County of Loudoun
Department of Planning
MEMORANDUM

SUBJECT: SPEX 2007-0056, SPEX 2007-0059, SPEX 2007-0060 and ZMOD 2007-0012 Play to Win Sports

DATE: March 12, 2008
TO: Mike Elabarger, Project Manager
Department of Planning
FROM: Lou Mosurak, AICP, Senior Transportation Planner *LM*
THROUGH: Art Smith, Senior Coordinator *(AS)* for AJS
SUBJECT: SPEX 2007-0056, SPEX 2007-0059,
SPEX 2007-0060, ZMOD 2007-0012—Play to Win Sports
First Referral

Figure 8
Existing Peak Hour Traffic Counts

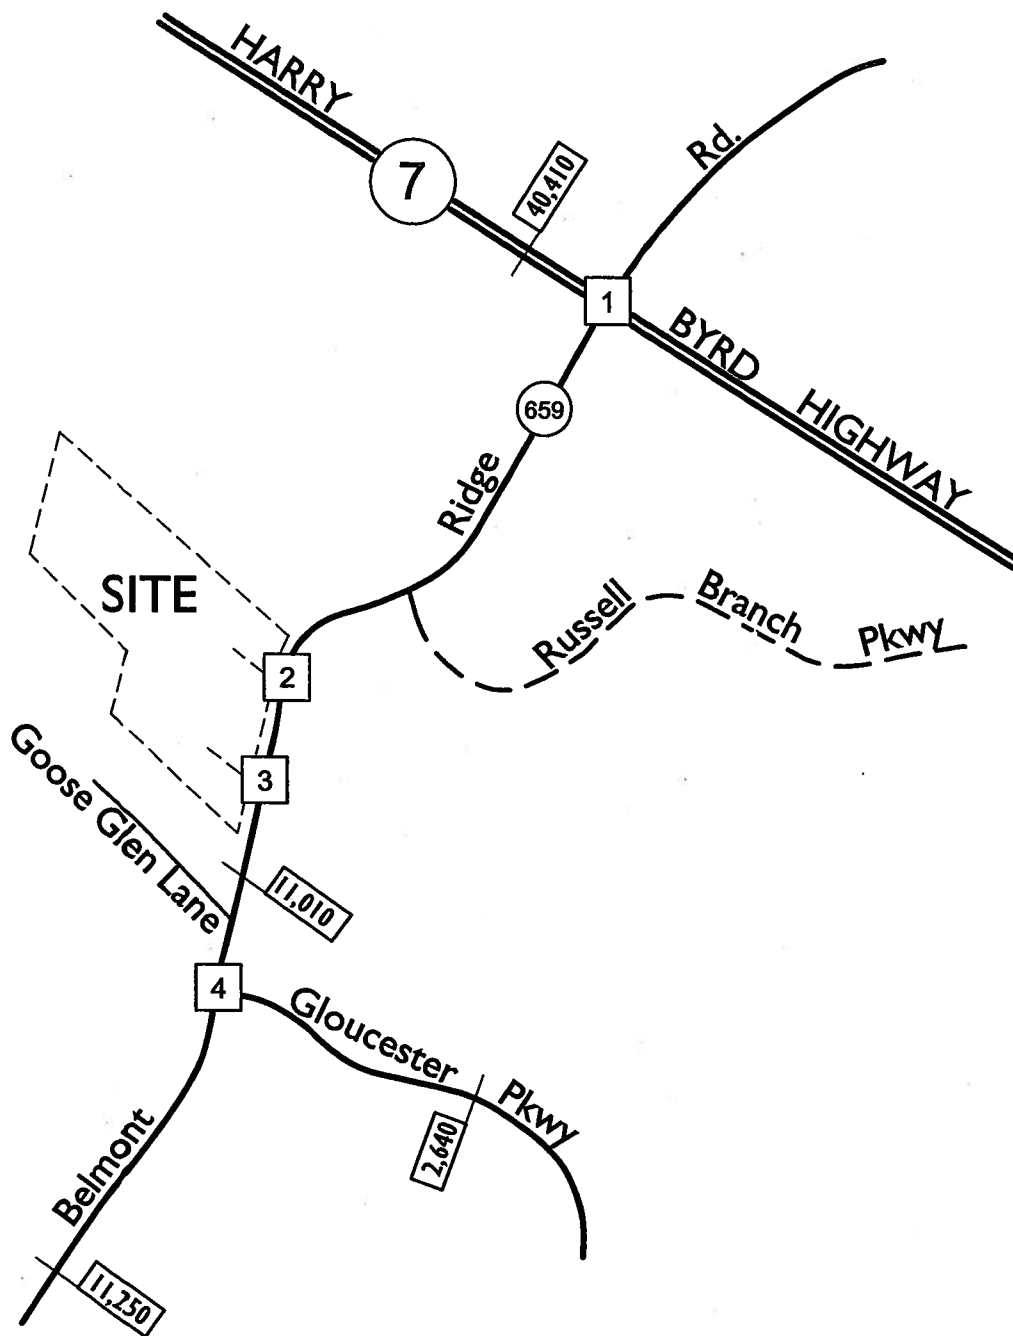
6. In Figure 8, the "Existing Peak Hour Traffic Counts" shown on Page 15 do not match the raw data. The intersection of Belmont Ridge Road and Gloucester Parkway clearly show this discrepancy.

Figure 17
Site-Generated Peak Hour Forecasts
and Directions of Approach, 2010

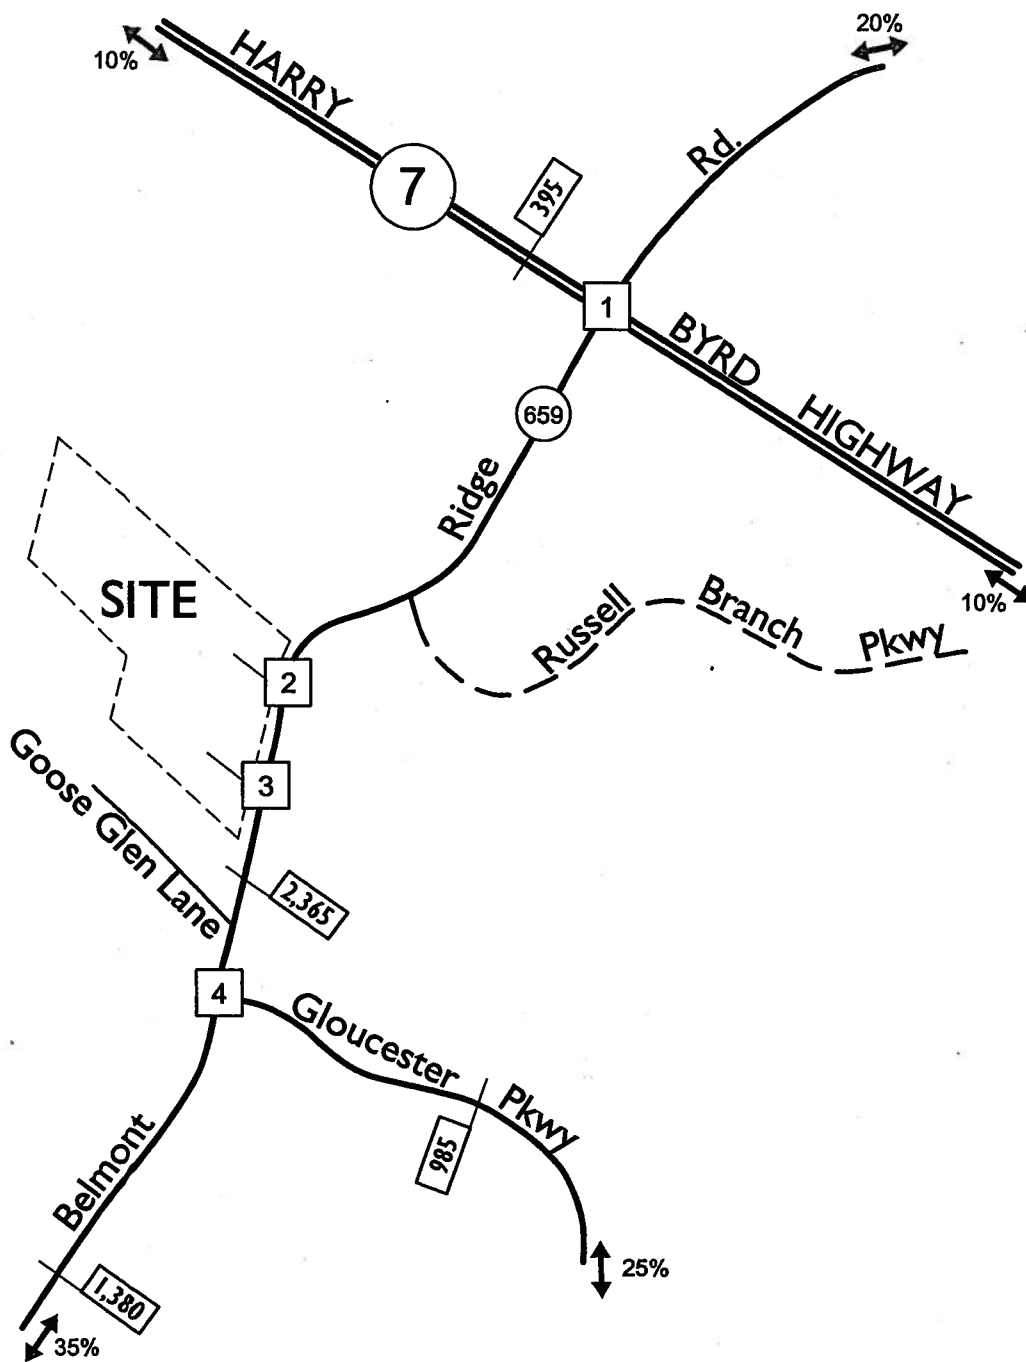
1. The page number references are not accurately indicated. For example Figure 17 is mentioned as being on Page 31, but it is on page 34.
2. Item 3 in the "Introduction" part of the TIA indicates VDOT's pre-scope of work meeting form is included in Appendix A, but it is not.

Figure 20
Total Future Peak Hour Forecasts, 2010

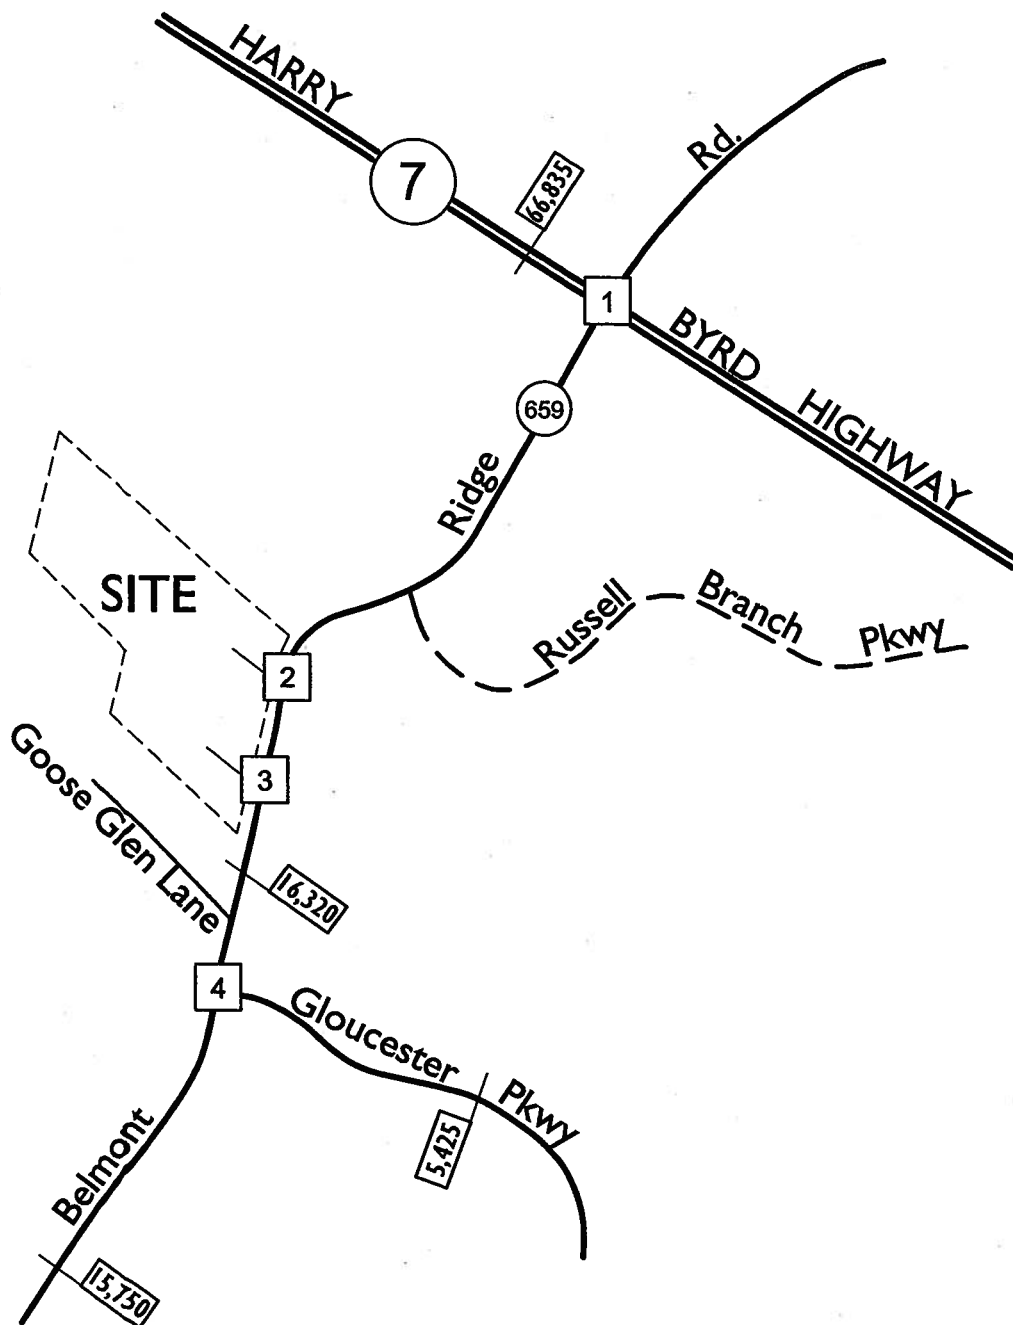
8. On Page 41, the second paragraph "Signal Warrant Analysis" mentions the ADT volumes used for the signal warrant analysis for the south site entrance were obtained from Figures 20 and 21, which show Total Future volumes for 2010 and 2015 respectively. Assuming a k-factor of 10%, the ADT used in signal warrant worksheets (Appendix M) couldn't be verified.

Figure 5
Future Lane Use and
Traffic Control, 2010

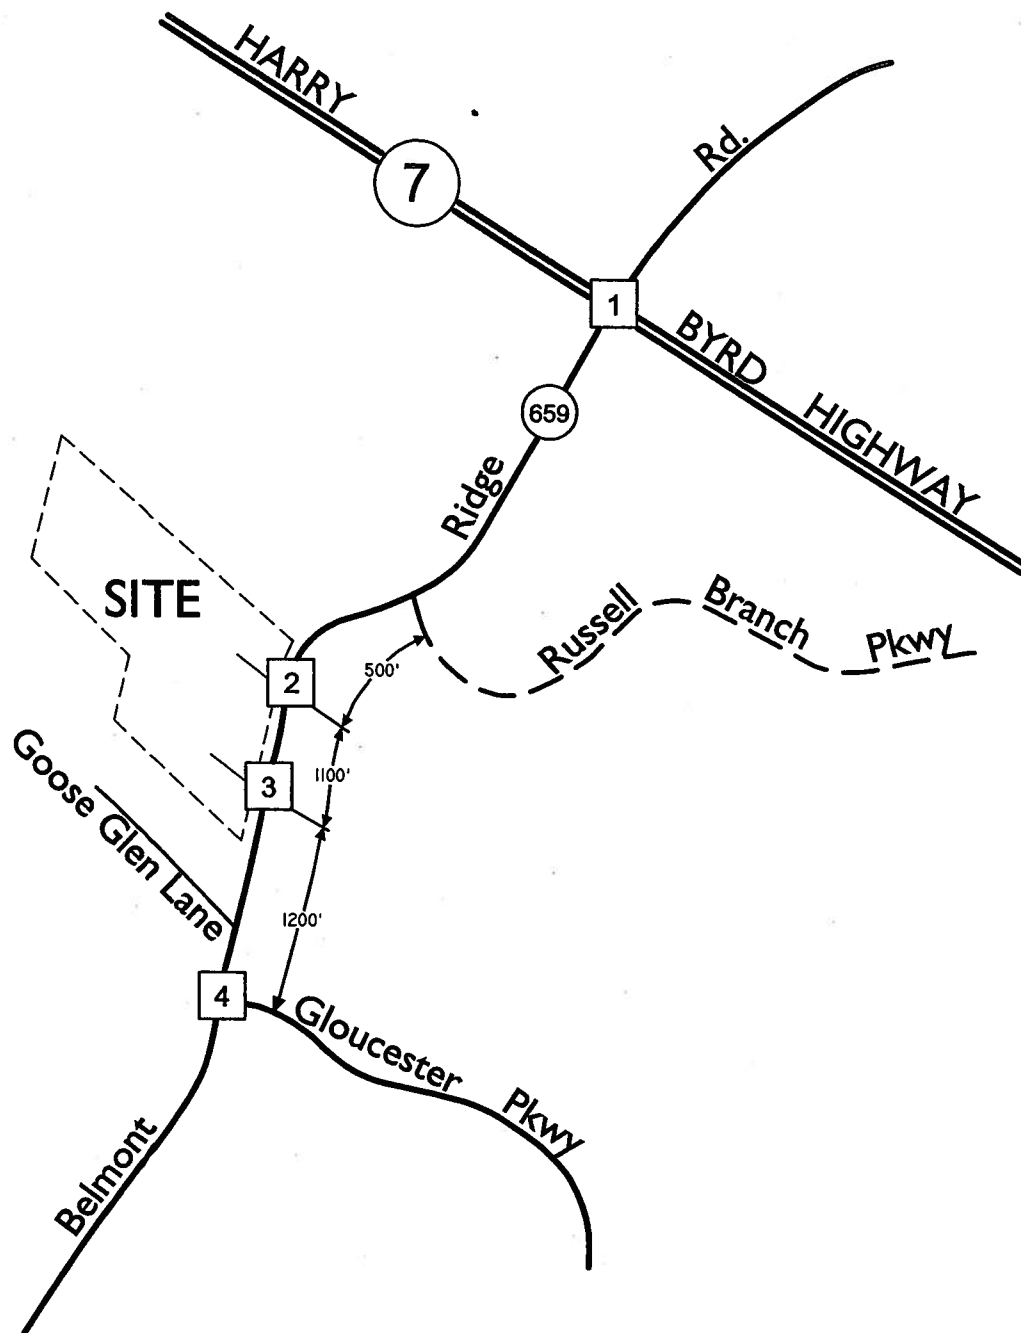
- d. The 2010 Future Lane Use and Traffic Control diagram (Traffic Study Figure 5, *Attachment 17*) does not depict a right turn lane into the site's northern entrance, though such a lane is discussed elsewhere in the study and is indicated as being warranted in the Turn Lane Warrant Analysis Summary (Traffic Study Table 8, *Attachment 21*). The SPEX plat depicts a right-out only egress at this location. The Applicant should clarify the configuration of the proposed northern entrance should the ingress/egress remain in subsequent submittals of these applications.

12. In Figures 5 & 6 the asterisk in the legend states "Required Background Improvements", but it does not identify who will make the improvements.
13. In Figure 7 the asterisk in the legend states "Improvements by others", but it is not clear who "others" are.

Figure 6
Future Lane Use and
Traffic Control, 2015

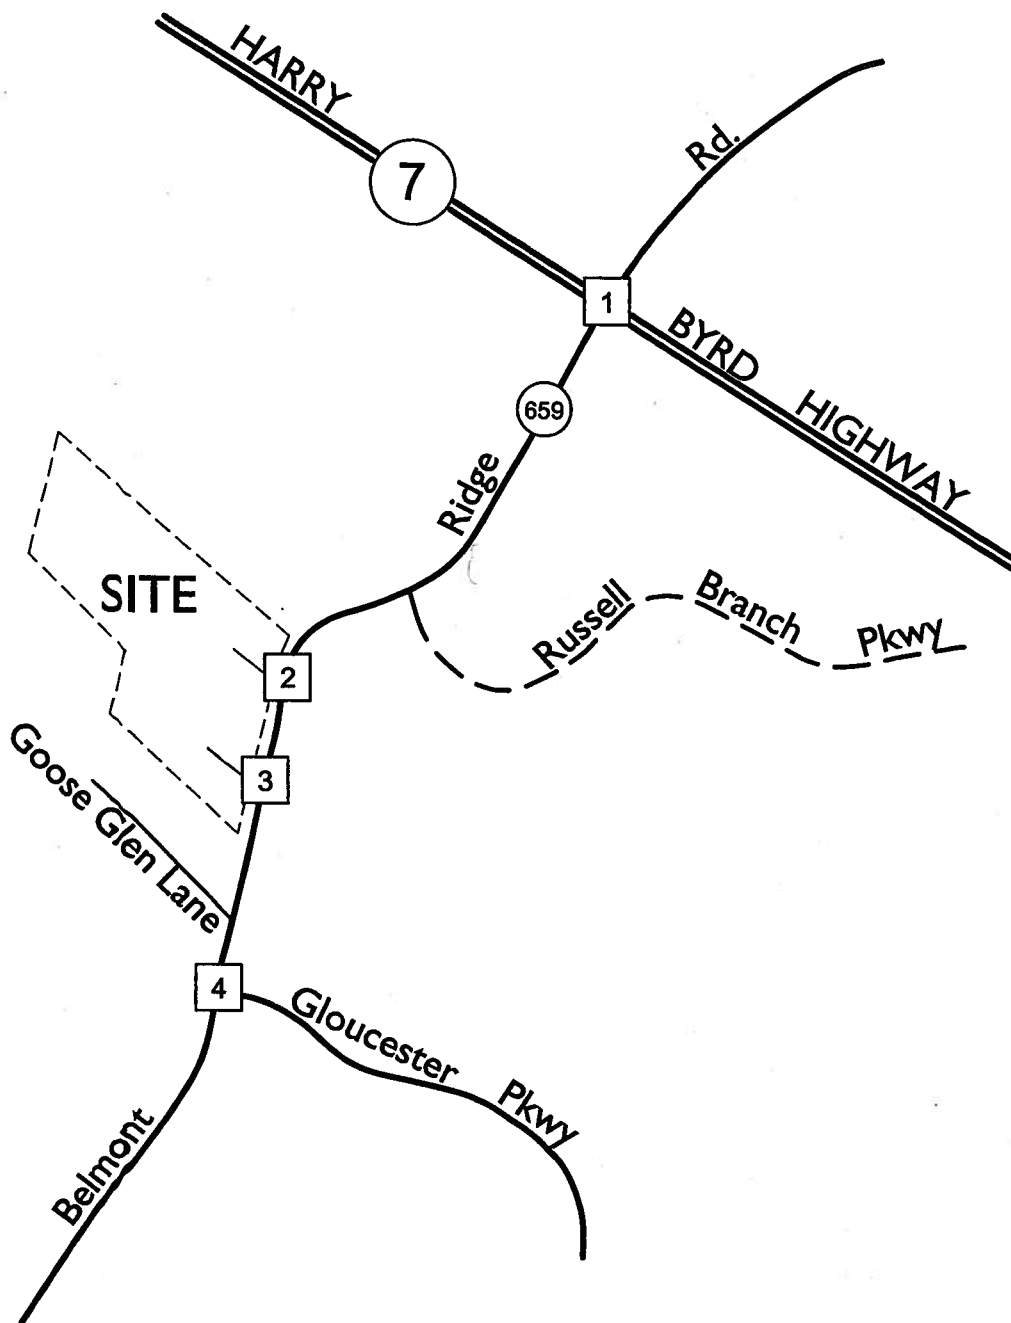
4. On Page 7, in the third paragraph the 15% rule schematic is in Appendix C, not B as indicated.
5. The Figure 6 "Future Lane Use" on Page 13 is missing a through lane on the Intersection 1 lane configuration for the northbound movement.
